CAMPUS WIDE, REPLACEMENT/REHAB SAN SEWER SYSTEM CAT 5.5
South Dakota State University
Brookings, South Dakota
OSE# R0323--03X/ARPA
2024

ADDENDUM NO. 1

November 6, 2024

SHEET NO.
1115

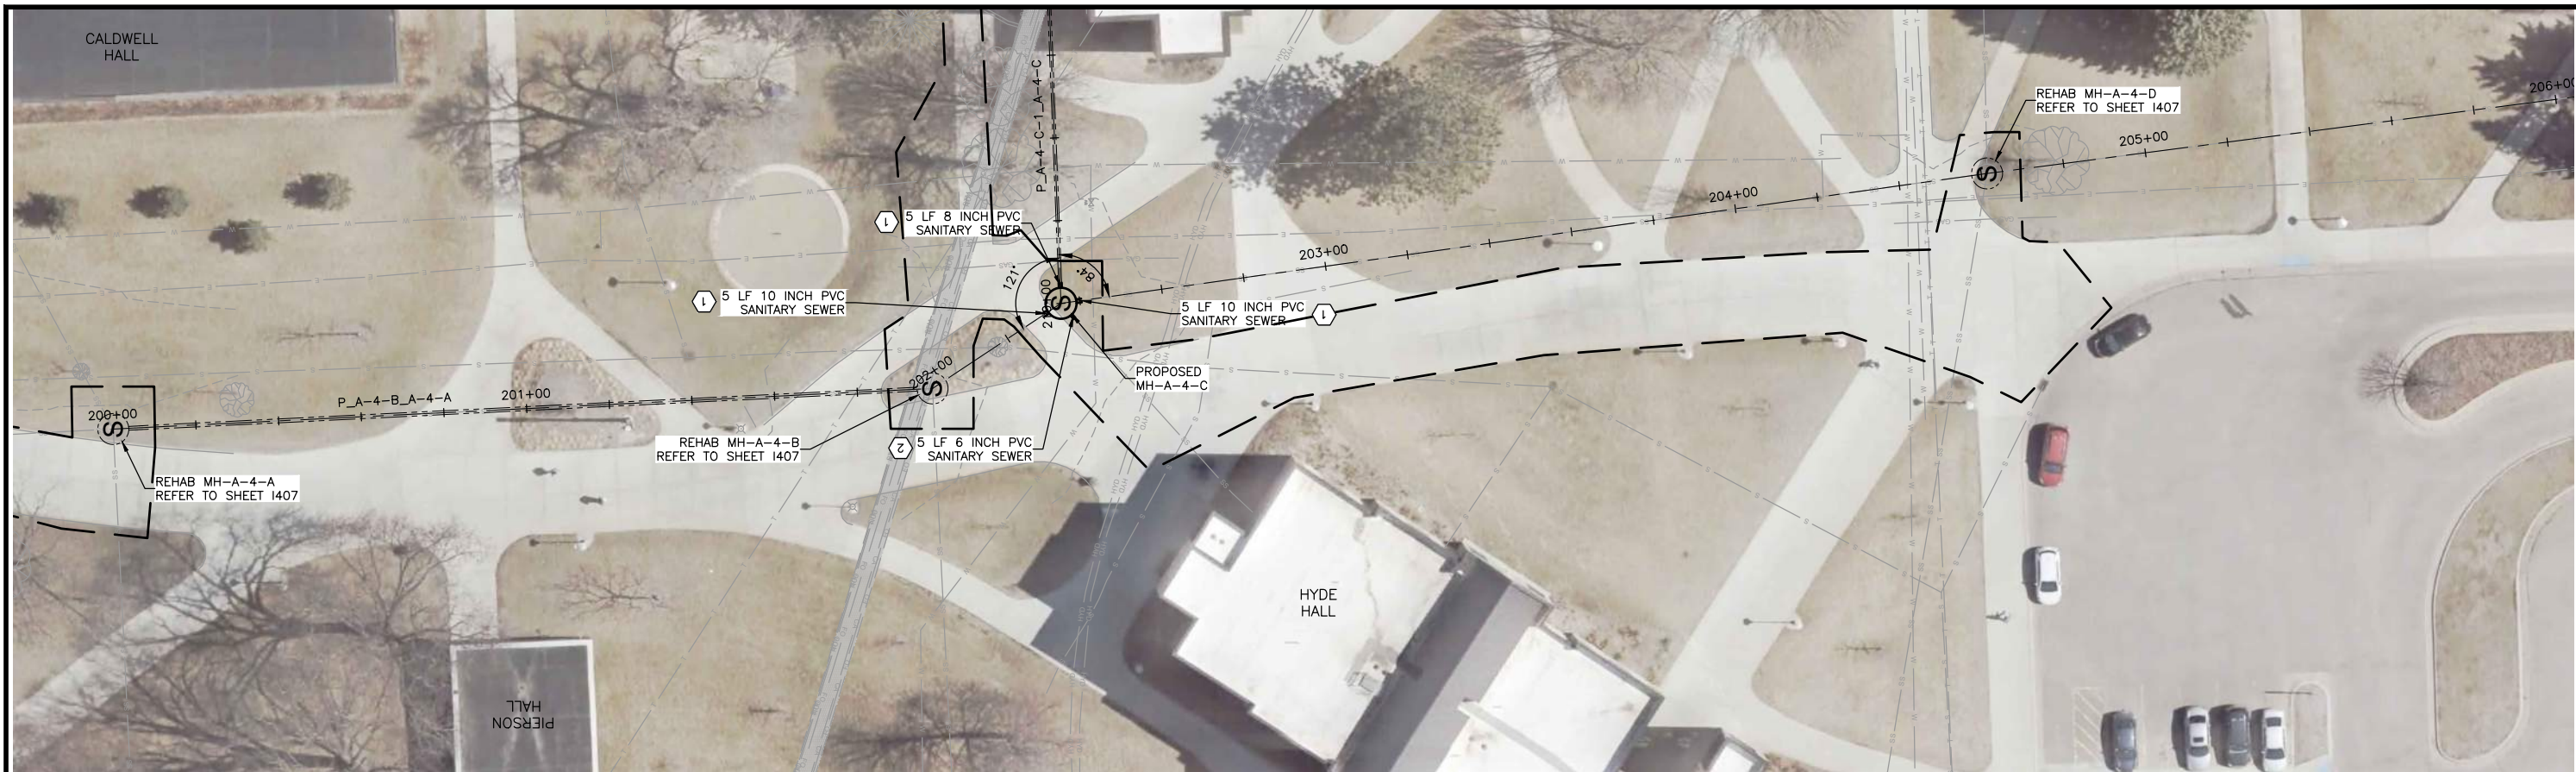
Modified call outs and keynotes.

SHEET NO.
 1116

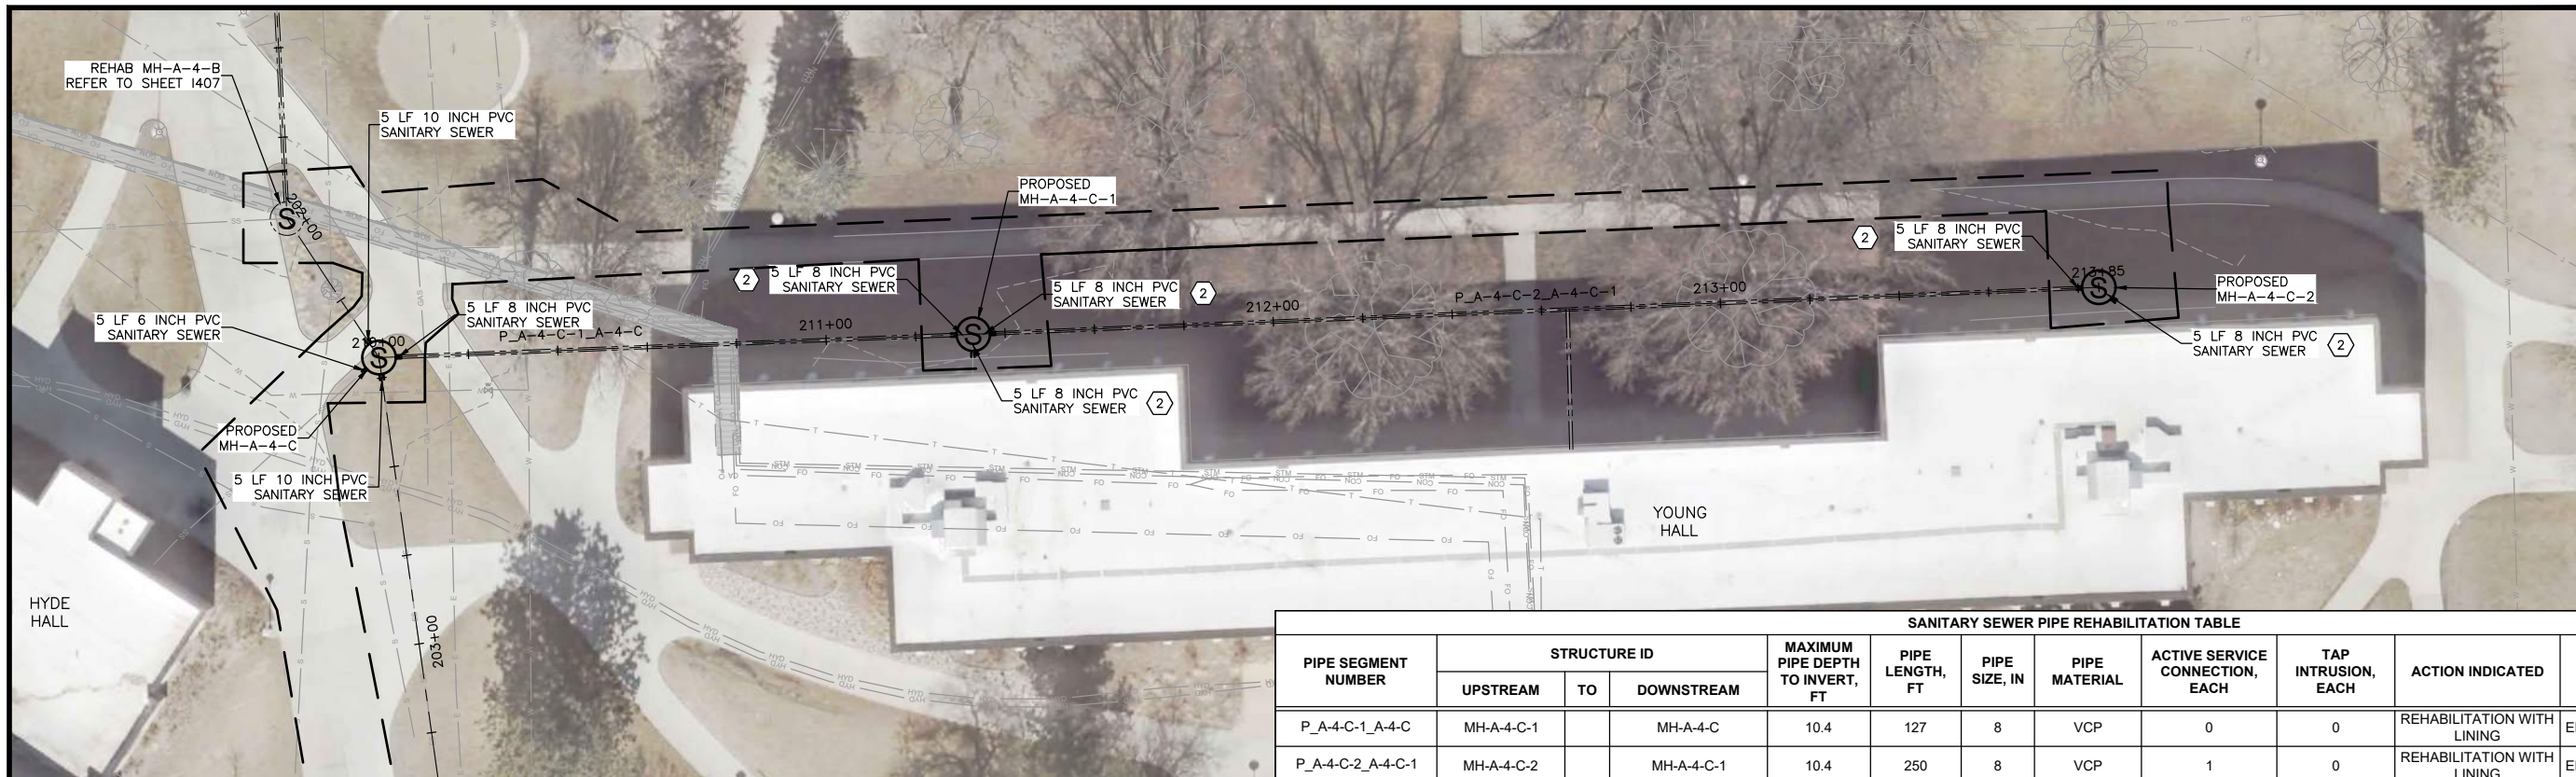
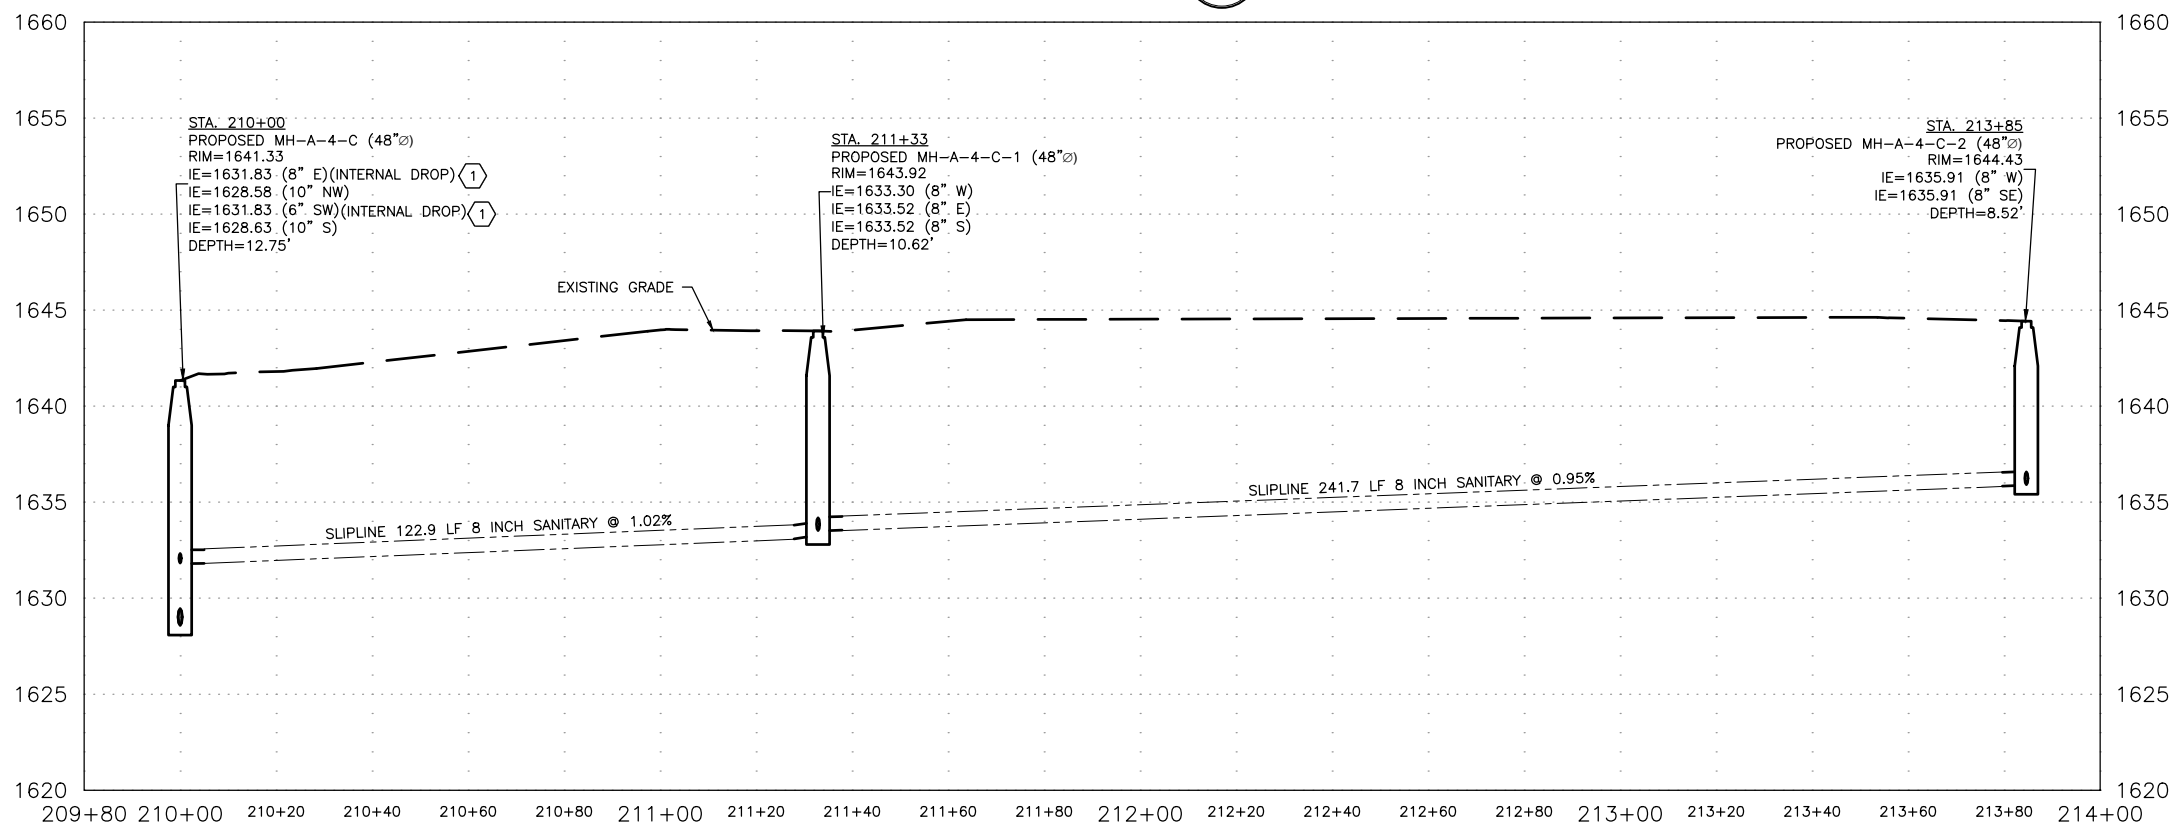
Modified call outs and keynotes.

SHEET NO.
1120

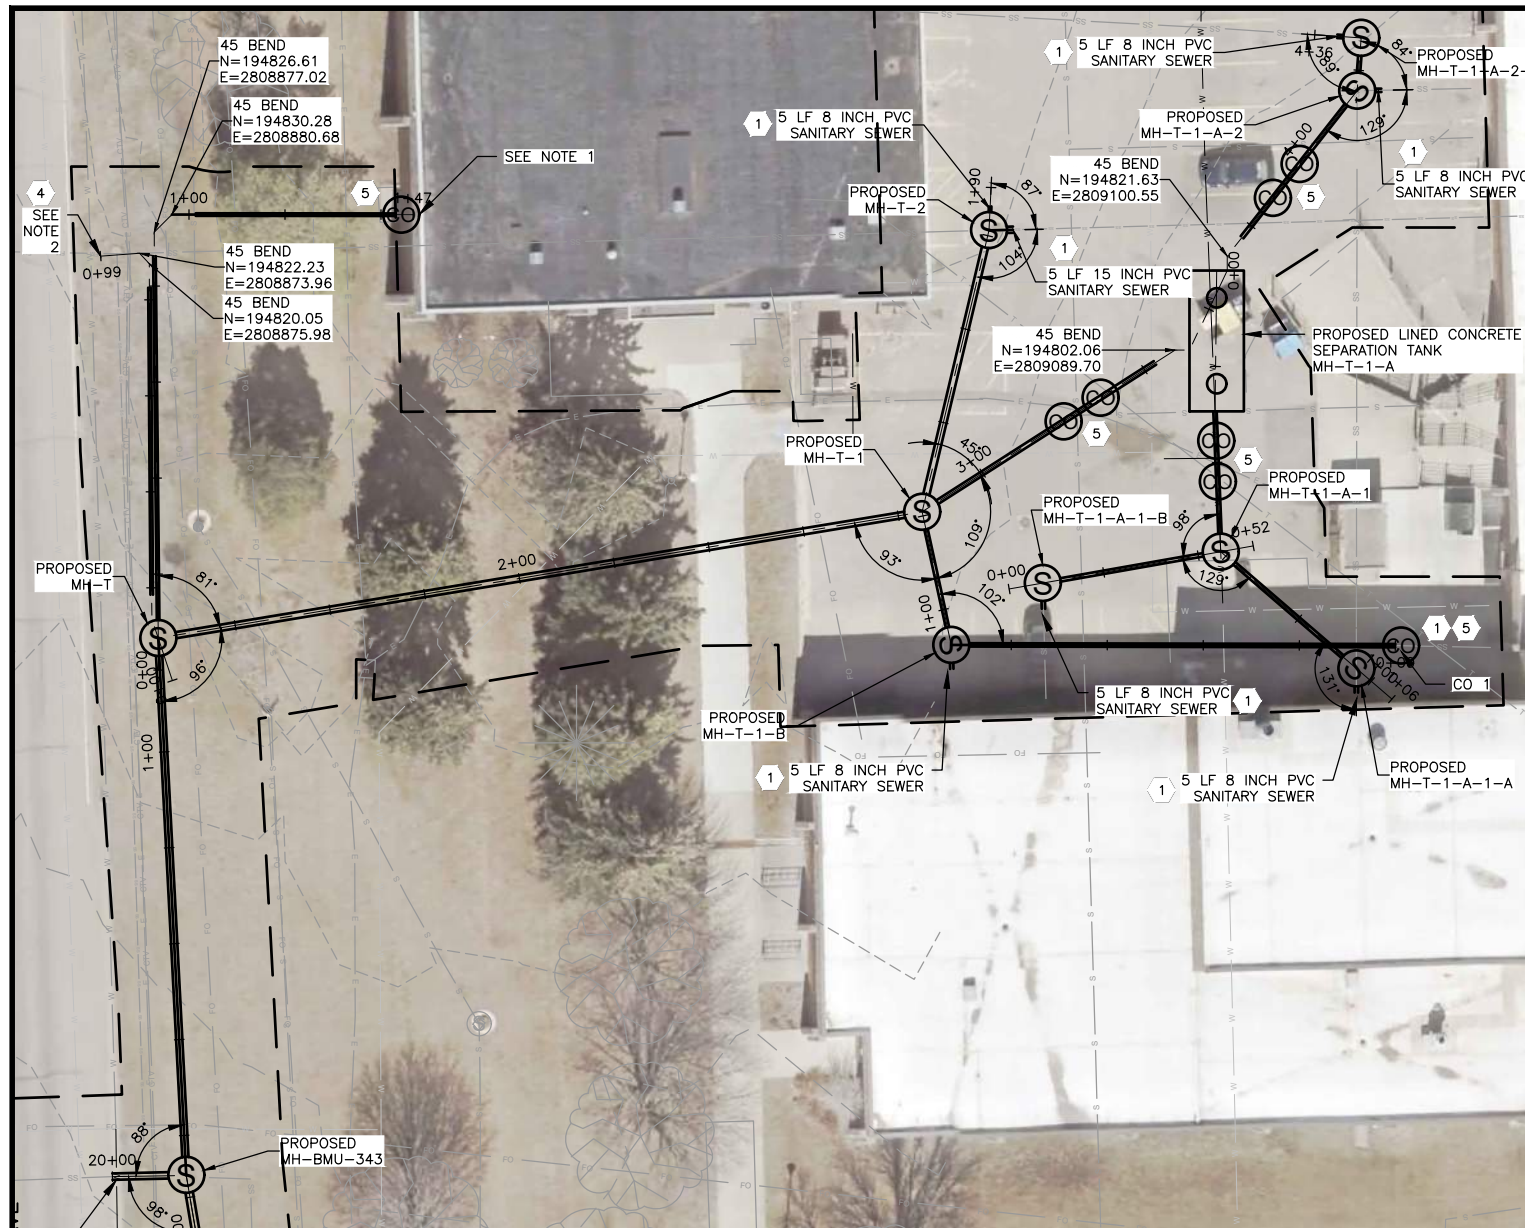
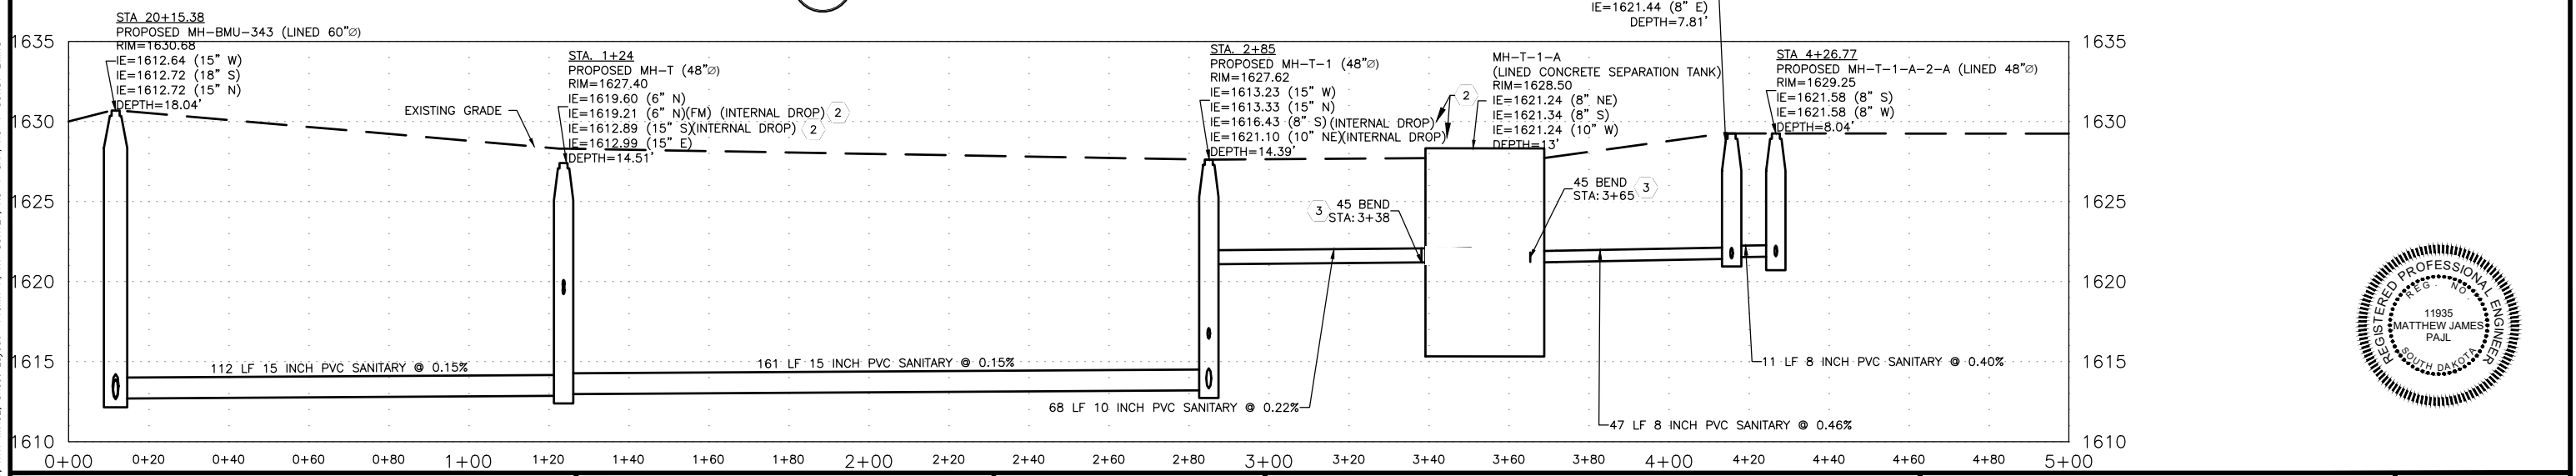
Modified call outs and keynotes. Modified rehabilitation table and added Detail #2, PLAN.
